**Public Comments on the Proposed Revisions to Section 4.2
Chapter 2 (SCR) of the
Control Cost Manual**

Chapter 2: Selective Catalytic Reduction (SCR)

Figure 5-2. Catalyst Exchange Frequency: Eastern Bituminous Coal

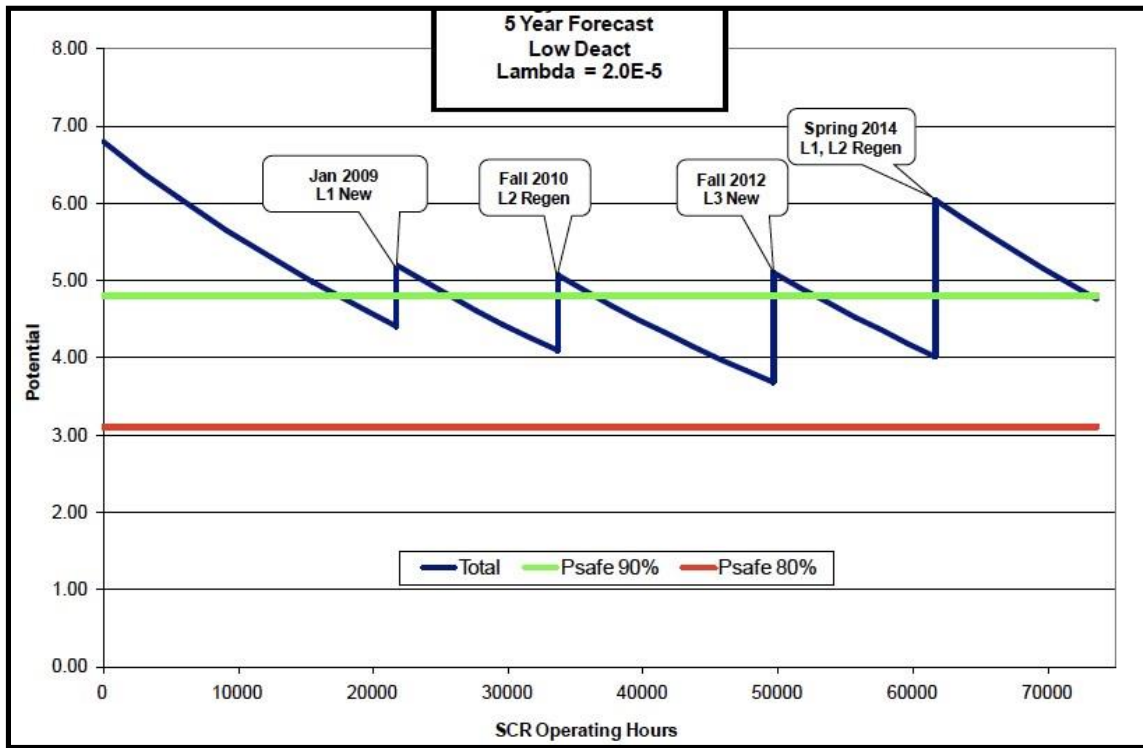
Figure 5-2 presents an example exchange rate based on one catalyst supplier’s analysis for a unit firing eastern bituminous coal. The metric of Figure 5-2 is the total reactor potential as comprised of the reactor potential of 3 layers in the reactor. Figure 5-2 shows that four catalyst exchange “events” are planned, installing five new layers of catalysts, over about 80,000 operating hours. One catalyst supplier reported that depending on wall thickness a total of 12

catalyst layers would be required in 20 years.⁶¹ Less frequent catalyst replacement schedules can be found but the experience reflected in Figure 5-2 is common.

Figure 5-3. Authentic Reactor Potential Decay: PRB Coal with Ash Blockage

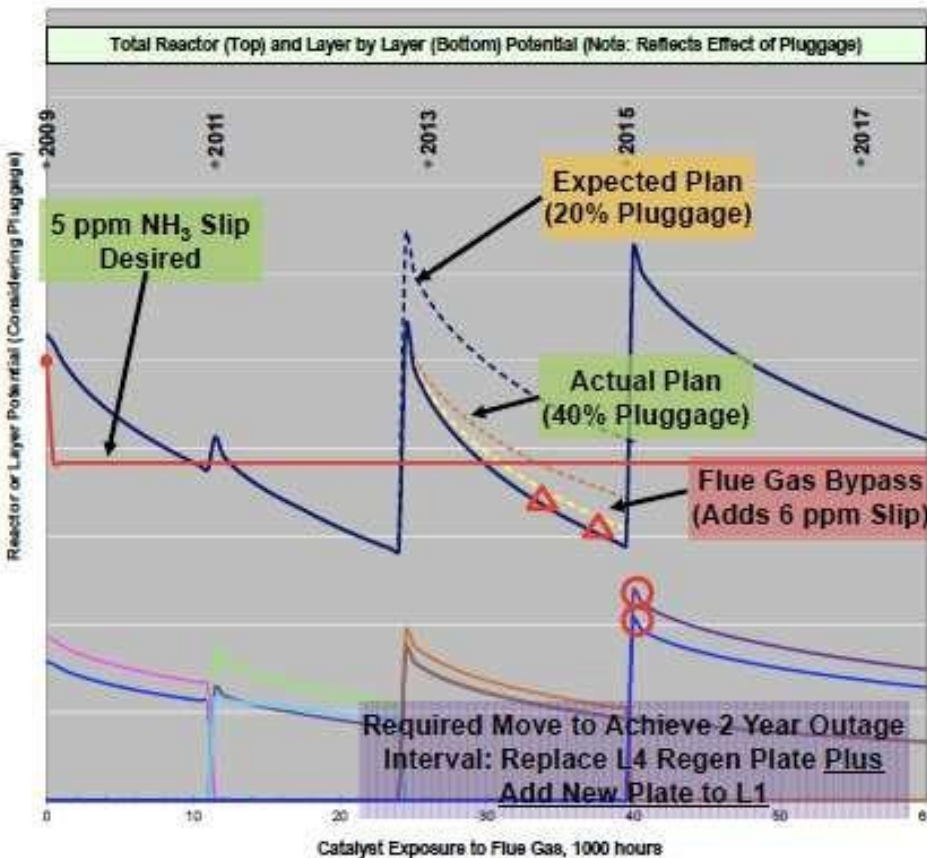
Figure 5-3 presents a more authentic catalyst management plan – showing the relative change in reactor potential for a large PRB-fired unit that incurred ash plugging.⁶³ Figure 5-3 shows the erratic rate of decay of reactor potential (on a relative basis) and how catalyst pluggage from ash affects the actual reactor potential realized. Figure 5-3 does show the owner abided by the original plan of a 24,000 operating hour changeout – but after about 12,000 operating hours the reactor potential was less than the minimum required for 5 ppm residual NH₃ – meaning residual NH₃ emissions were higher than planned. Figure 5-3 also shows how the role of catalyst pluggage can compromise reactor potential, and how in this case adding two layers of catalyst

(changing one and adding a second to the empty spare cavity) is necessary to achieve 2 operating years between outages.

EPA cites the availability of guarantees from catalyst suppliers as a sufficient basis to construct a catalyst management strategy. Catalyst guarantees are of limited benefit – they typically assure that specified NO_x removal can be provided for a given operating time, assuming the owner has maintained the specified process conditions, with only occasional exceptions. In reality, changes in the fuel source or operating conditions prevent the design process conditions from being fully attained. Further, a catalyst performance guarantee “payoff” cannot be interpreted the same as a guarantee for a consumer good – the “make right” conditions are such that the owner invariably incurs additional cost. In some instances the guarantees are contested, depending on how the owner operates the unit and the guarantee language is constructed. Consequently, catalyst guarantees are useful to inform but do not dictate the catalyst replacement schedule. In summary, given the variability in catalyst deactivation rates, and the unpredictable role of factors such as ash plugging, it is not possible to confidently select a “default” catalyst replacement frequency. Replacement periods ranging from less than one year to 3 years have been observed, regardless of a suppliers guarantee.
